Access Compliance Report Public Rights-of-Way (Curb Ramps)

Main Street: LEON_WAY Cross Street: HOLT_AVE Location: NW

ADA ID: RPRK220121120726 Ramp Type: Type 4 - Parallel Initial Pass/Fail: Fail Overall Compliance: No Severity Score: 15

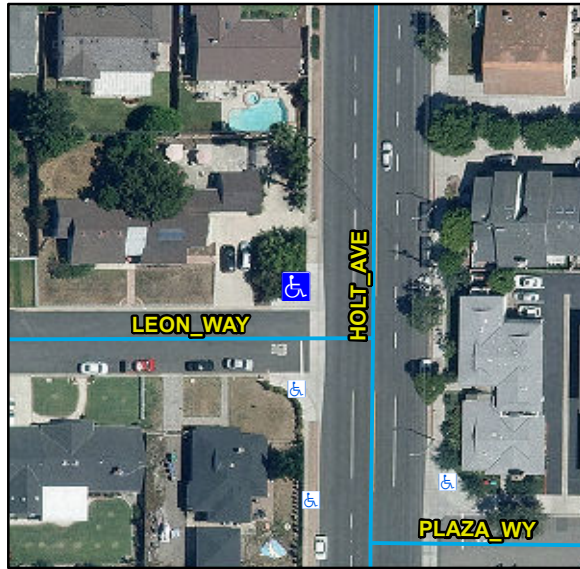
R304.3.2, STD 1115

Remove & Replace Curb Ramp With Two New Directional Ramps or Equivalent.
